Submission re:

CONCEPT DEVELOPMENT APPLICATION FOR A
MIXED-USE DEVELOPMENT WITH INFILL
AFFORDABLE HOUSING-EDGECLIFF
136-148 NEW SOUTH HEAD ROAD, EDGECLIFF

Application Number SSD-76855210

Chairperson (W. Bracey) and Treasurer (A. Drozda) of the Strata Committee,
on behalf of the affected residents of 164 New South Head Rd, Edgecliff
25th February, 2025

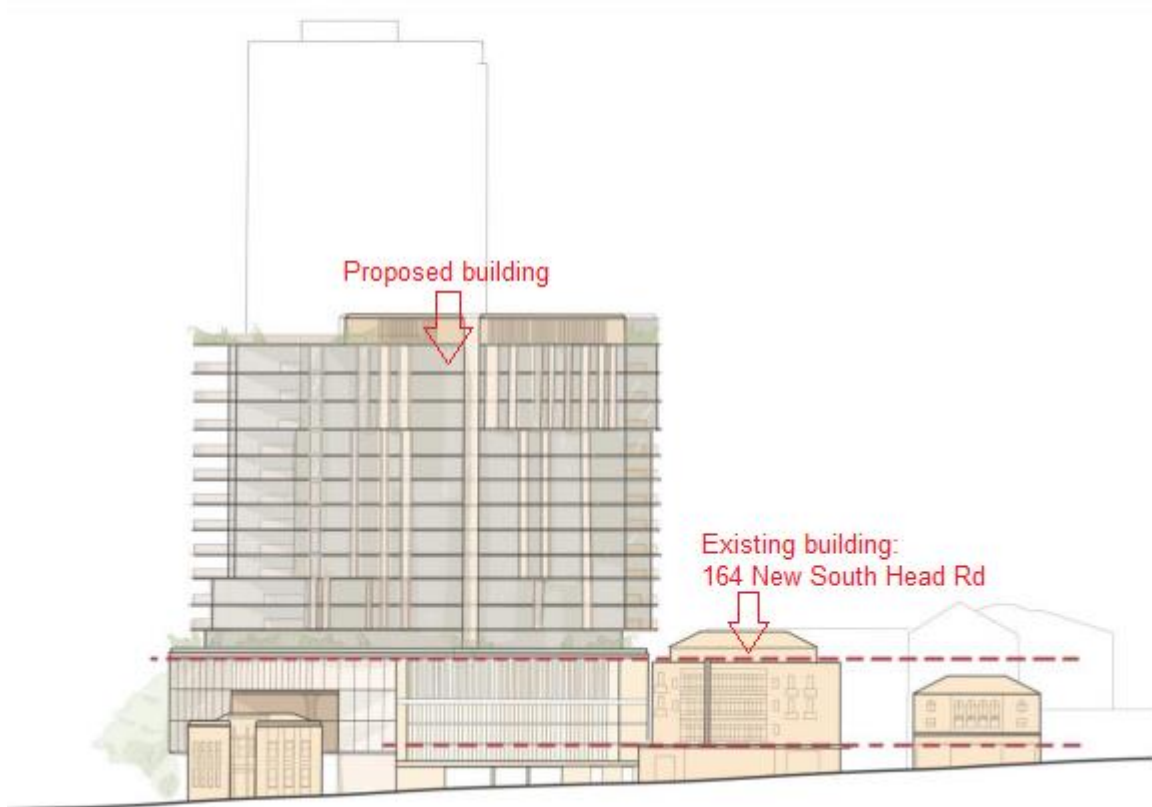
The architects commissioned by LendLease to provide the initial rendering of the building concept were fully aware of these guidelines, as evidenced by the early concept drawings (see the gap between the buildings on the right side of the image). Despite this, the developer has chosen not to adhere to the required separation distances, indicating a disregard for established design standards. This raises concerns about the developer’s commitment to complying with the NSW Apartment Design Guide, which aims to promote best practices in building design, ensuring quality living environments and the harmonious integration of new developments within existing communities.

That image was published in the article that appeared at the time of the development's announcement.

Yet, the subsequently developed plans for the building focused on maximising the footprint and profitability for the developer, disregarding the surrounding neighbourhood and long-established architecture. As a result, the currently **submitted version of the building design allows for almost no distance between the buildings**, which violates established design rules and best practices.

New South Head Road (Looking North)

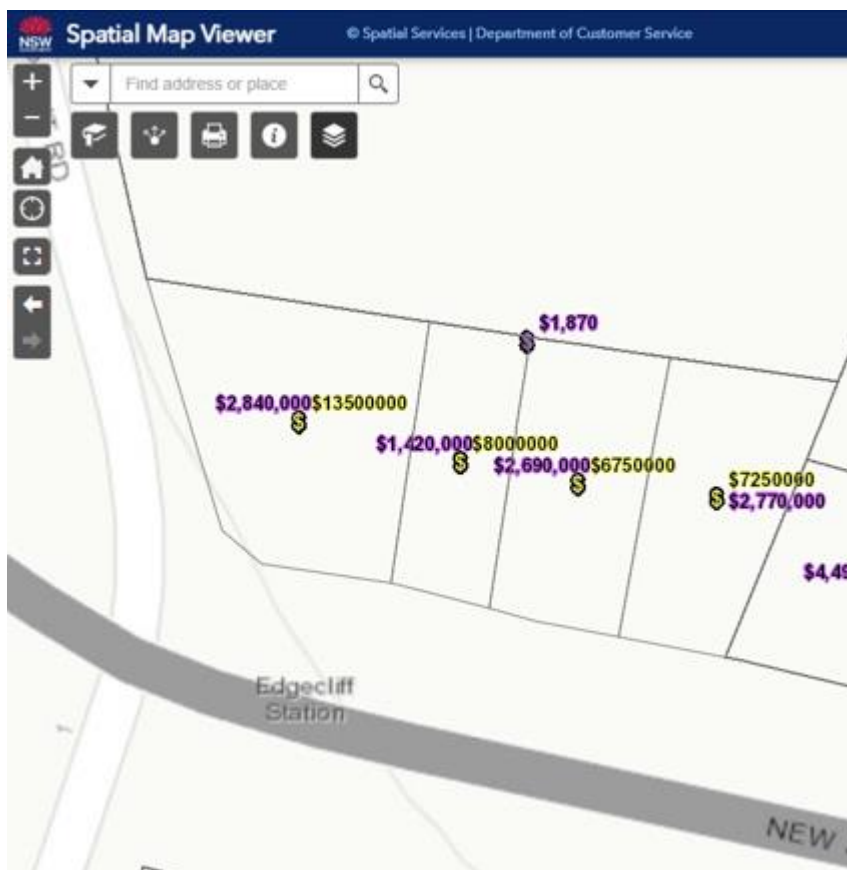
- 0 setback on Ground Floor facing blank wall;
- **3m setback on Level 01 - Level 04 (whole 12m short of required 15m!)**
- 6m setback on the tower

Only some indication of how close the proposed building will be located to the adjacent habitable rooms of 164 New South Head Rd is provided in the *Appendix L Consultations Outcomes Report* p.45:

We would fully support the LendLease development if the prescribed offsets were accommodated in the design of 1 Darling Point Rd.
